MECKLENBURG COUNTY
DEPARTMENT OF ENVIRONMENTAL HEALTH

APPLICATION FOR SOIL INVESTIGATION

SITE EVALUATION

(Ground Absorption Sewage Disposal)

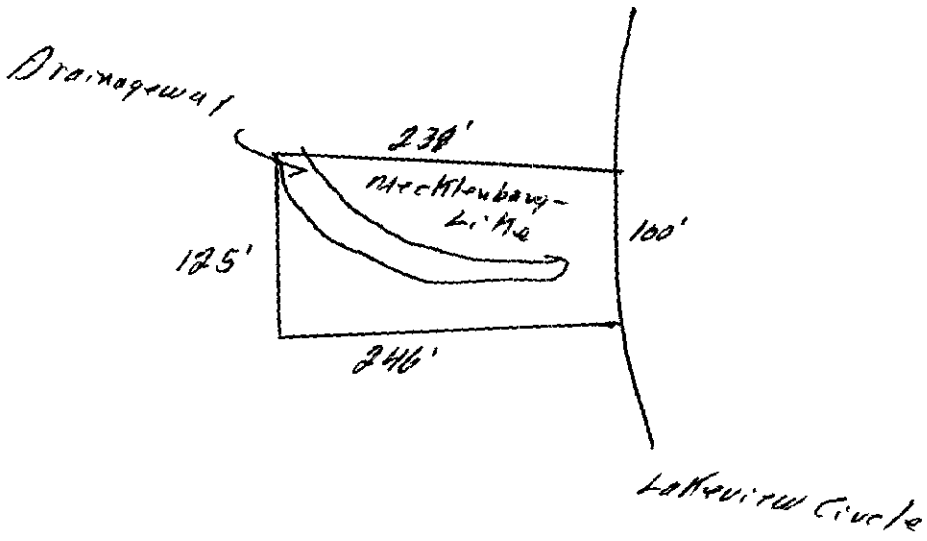
FACTORS	AREA 1	AREA 2	AREA 3	AREA 4
1. SLOPE (%)	(S) PS U 9-15%	(S) PS U 8-15%	S PS U	S PS U
2. SOIL TEXTURE (12-36 inches) Sandy, Loamy, Clayey (Note 2-1 Clay)	S PS (U) 2-1 clay	S PS (U) 2-1 Clay	S PS U	S PS U
3. SOIL STRUCTURE (12-36 inches)	S (PS) U weak blocky	S (PS) U weak blocky	S PS U	S PS U
4. SOIL DEPTH (inches)	S PS (U) 12-24"	S PS (U) 12-24"	S PS U	S PS U
5. RESTRICTIVE HORIZONS (Inches) (Impervious strata, Rock)	S PS (U) 12" to saprolite	S PS (U) 12" to saprolite	S PS U	S PS U
6. SOIL DRAINAGE/GROUNDWATER (external and internal)	S (PS) U 24-36" to ground water	S PS (U) depression	S PS U	S PS U
7. OTHER (Specify)	S PS U	S PS U	S PS U	S PS U
8. SOIL GROUP	10B	10B		
9. SITE CLASSIFICATION	unsuitable	unsuitable		
10. SOIL SERIES	Mecklenburg-Cecil	Drainageway

At your request, a field investigation was conducted on the property designated above and was classified unsuitable for the installation of a ground absorption sewage disposal system. A copy of the site evaluation report is enclosed for your information.

Sites classified as unsuitable may be utilized for soil absorption disposal systems provided engineering, hydrogeologic, soil and environmental studies indicate that a suitable septic tank system or a suitable alternate system can be reasonably expected to function satisfactorily.
